Project No. 073-81694.0022

**RE: RESPONSES TO SPECIFIC COMMENTS INCLUDED IN CDPHE RFI #4
PIÑÓN RIDGE PROJECT, MONTROSE COUNTY, COLORADO**

Golder Associates Inc. (Golder) has prepared this letter to provide responses to comments from the Colorado Department of Public Health and Environment (CDPHE) in the Request for Information (RFI) #4 as provided in the letter from Steve Tarlton dated 21 September 2010. This letter addresses specific comments included as Attachment 1 to RFI #4 prepared by Mr. Clay Trumpolt, and the comment from Mr. Larry Bruskin included as Attachment 2 to RFI #4.

Figure 1: Phase 1 tailings deposition.

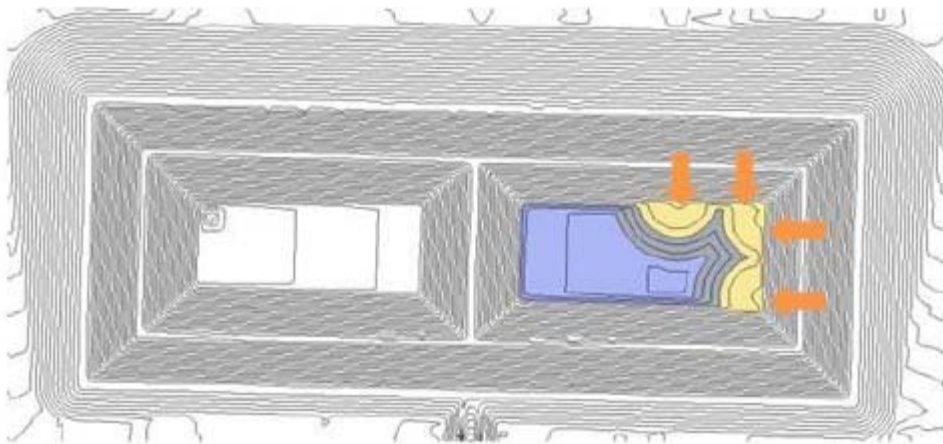
Please provide a short narrative of how the spigots would be operated for the first tailings cell under normal operating conditions.

- Phase 1 – Deposition commences within sub-cell A1 (or A2) in the vicinity of the underdrain sump to provide approximately 10 feet of tailings deposition over the sump area. This phase of deposition is illustrated conceptually in Figure 1, showing four (4) spigot points. This phase of deposition provides coarse-grained underflow tailings over the underdrain sump to enhance the long-term effectiveness of the tailings underdrain system;
